ADDENDUM NO. 02
To Drawings and Specifications dated 02/07/24

Date: FEBRUARY 7, 2024

PROJECT: **Warner Middle School HVAC Upgrade & Modernization**
A#04-121954
Westminster School District

2 ROOF PLAN - BLDG C4
1/8" = 1'-0"

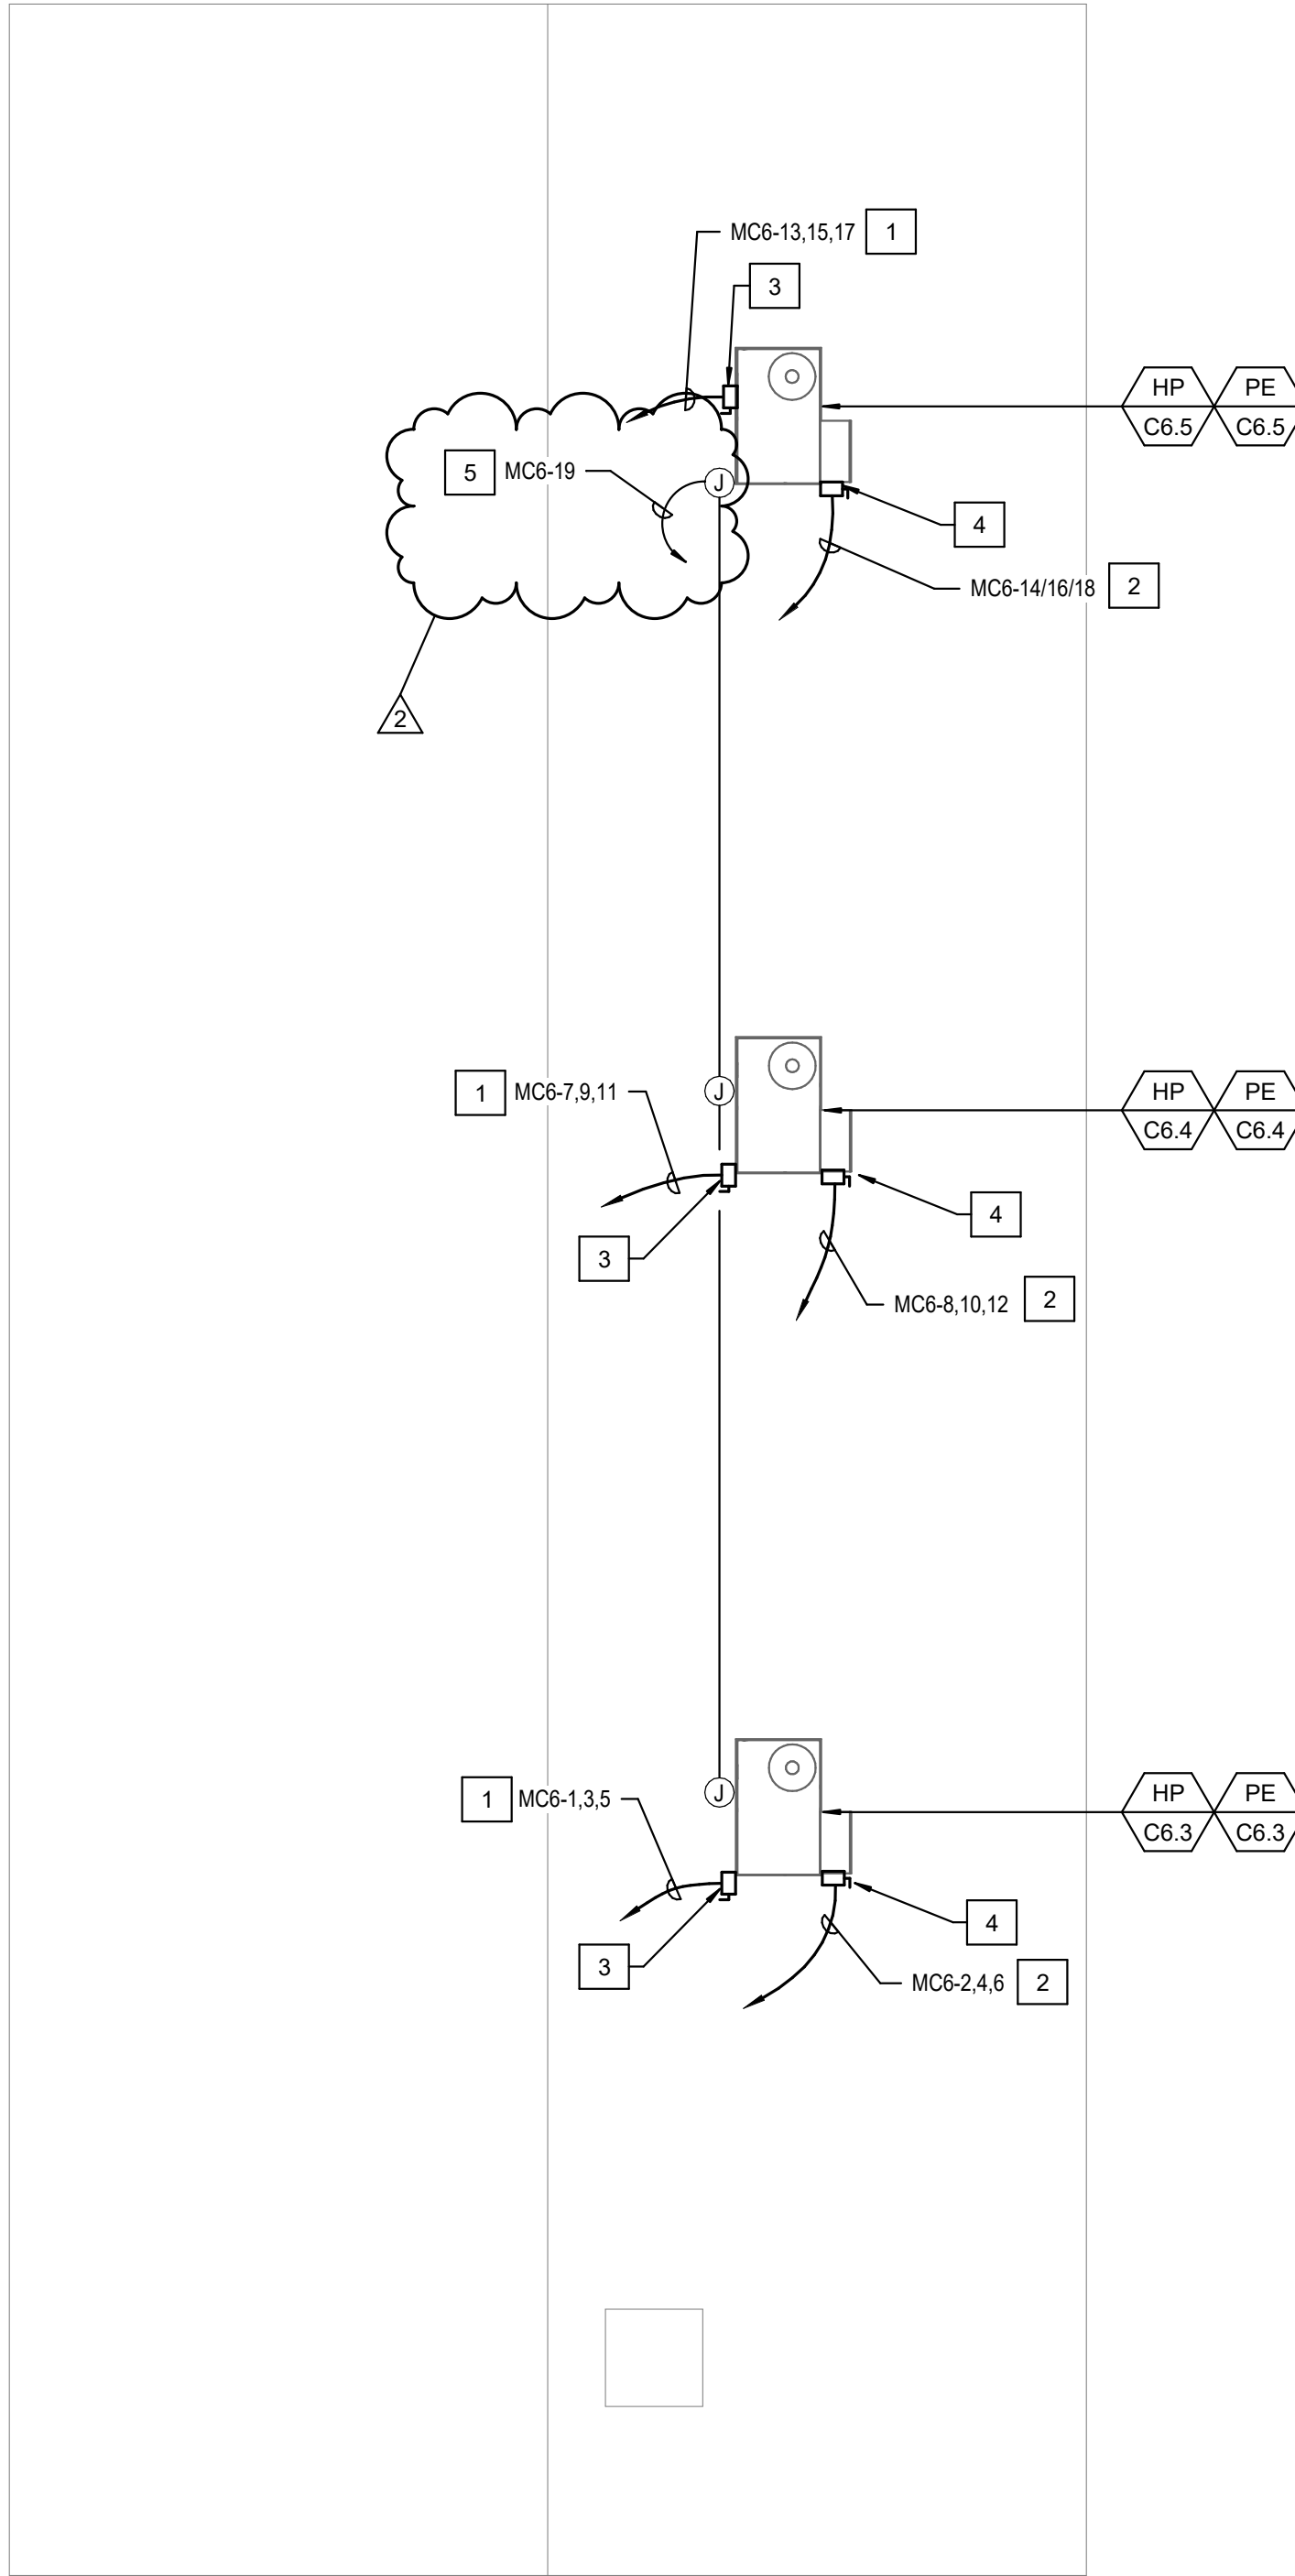
1. Details 1-3
 - a. Added 120V circuits for convenience outlets in rooftop units.
